Subject: CALIFA-SiTracker-GLAD geometry conflict
Posted by Anna Corsi on Wed, 08 Mar 2017 15:26:54 GMT

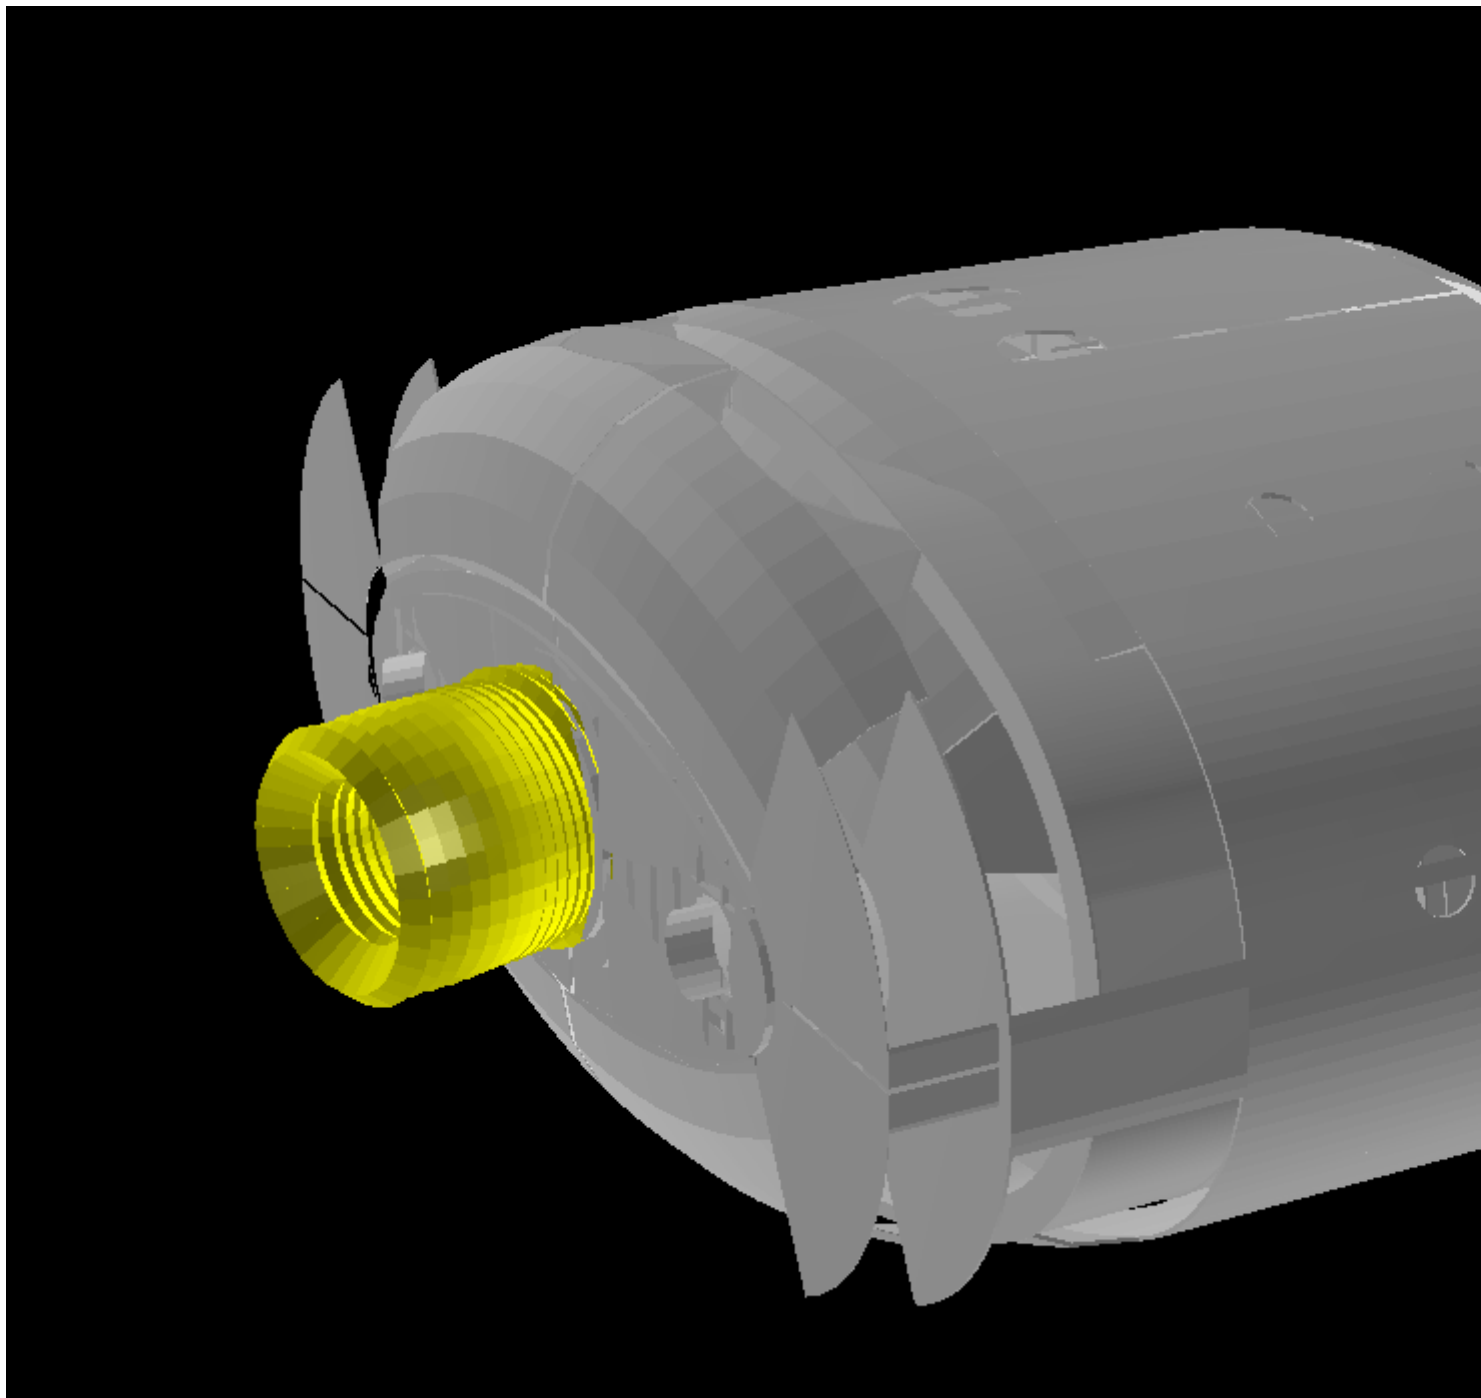
I find a conflict of geometry among the following detectors, as in attached picture.
  detGeo.Add(new TObjString("GLAD"),   new TObjString("glad_v13b.geo.root"));
  detGeo.Add(new TObjString("CALIFA"),   new
TObjString("califa_17_v8.11_cc0.2.geo.root"));
  detGeo.Add(new TObjString("STaRTrack"),   new

Could you tell me which detectors should be moved to simulate experiments with setup
expected for 2018?

If this is true, the magnet is misplaced by around half a meter in this geometry file.

Hello Anna,
here is my view of how to solve this problem: We used to have the target Position at x=0, y=0 and z=0 per Definition. The distance from the target position to the entrance flange of GLAD is 1062 mm. And Califa has also a nominal position relative to the target. If both are at this position there should be now overlap anymore.

File Attachments
1) 1211.jpg, downloaded 675 times

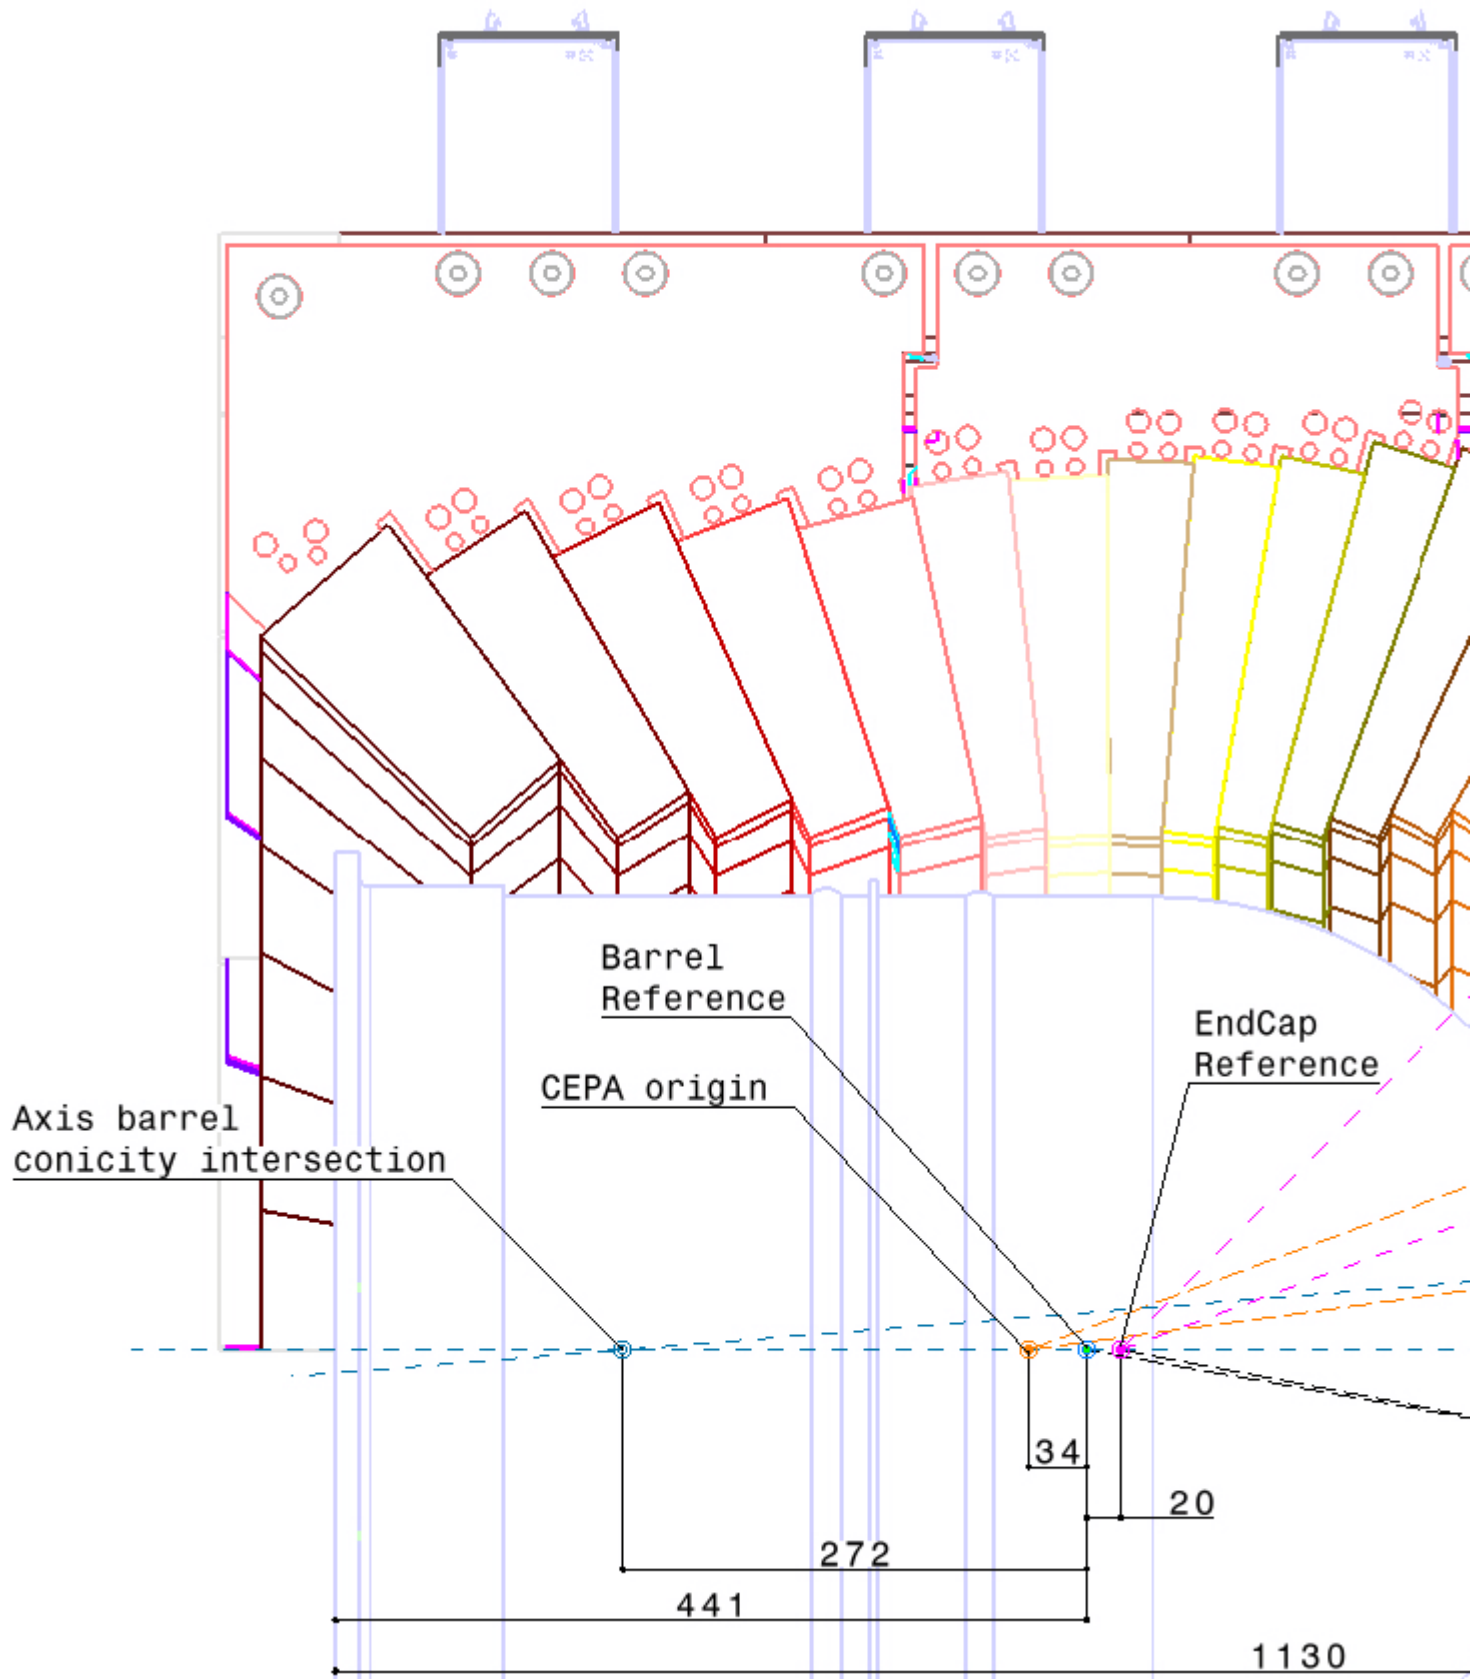
last time I was testing the CALIFA position, it was correctly located with respect to the nominal target position.

For a fast check to determine if CALIFA is correctly centered, you could find where the origin is

in your plot or simply visualize a reaction vertex...
the CALIFA barrel should be located as it is in the attached picture (side view).
A displacement of half a meter as it is shown in your pic would mean that the vertex could be
located outside the Barrel.
